# Access Compliance Report

## Public Rights-of-Way

Intersection ID: 24356	Main Street: BEVERLY_CREST_BV	Cross Street: CAMAROSS_DR	Location: NE
ADA ID: 900311BDED76	Ramp Type: Perp	Initial Pass/Fail: Fail	Overall Compliance: No
Severity Score: 12.5			
Codes/Mitigation Info/Possible Solution		Field Measurements/Component Compliance

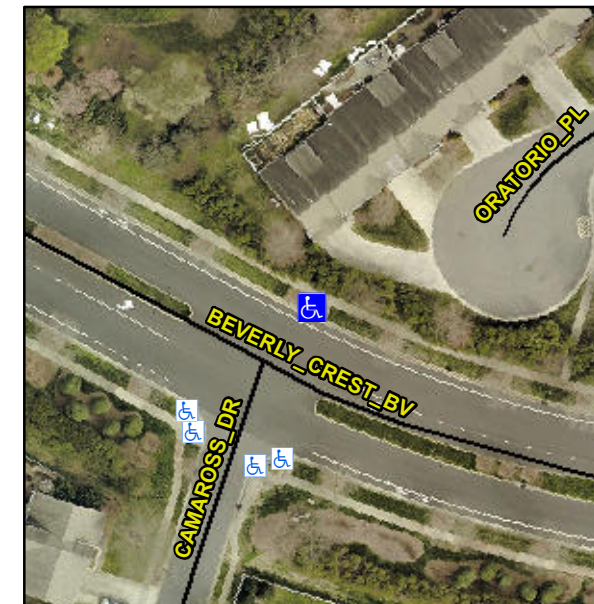
**Not Found, R304.2.2**

Compliance	Description	Data	Compliance	Description	Data
N/A	Ramp Length (in)	95.5	No	Ramp Slope (%)	8.5
Yes	Ramp Width (in)	120.0	Yes	Ramp XSlope (%)	0.5
N/A	Flare Type LT	N/A	N/A	Flare Type RT	N/A
N/A	Flare Slope LT (%)	N/A	N/A	Flare Slope RT (%)	N/A
N/A	Flare Traversable LT?	N/A	N/A	Flare Traversable RT?	N/A
N/A	Landing Length (in)	N/A	N/A	DWS Provided?	N/A
N/A	Landing Width (in)	N/A	N/A	DWS Contrast?	N/A
N/A	Landing Slope (%)	N/A	N/A	DWS Length (in)	N/A
N/A	Landing X Slope (%)	N/A	N/A	DWS Full Width?	N/A
N/A	Landing Curb? (Y/N)	N/A	N/A	DWS Offset (in)	N/A
N/A	Shared Landing?	N/A			
N/A	Gutter Ponding?	N/A	N/A	Gutter Slope (%)	N/A
N/A	Gutter Lip Ht (in)	N/A	N/A	Gutter X Slope (%)	N/A
N/A	Painted X Walk1?	No	N/A	Painted X Walk2?	N/A
	X Walk 1 Direction	To S		X Walk 2 Direction	N/A
N/A	X Walk 1 Width (in)	N/A	N/A	X Walk 2 Width (in)	N/A
	X Walk 1 Slope (%)	2.6		X Walk 2 Slope (%)	N/A
	X Walk 1 X Slope (%)	0.6		X Walk 2 X Slope (%)	N/A

**Remove & Replace Entire Ramp.**
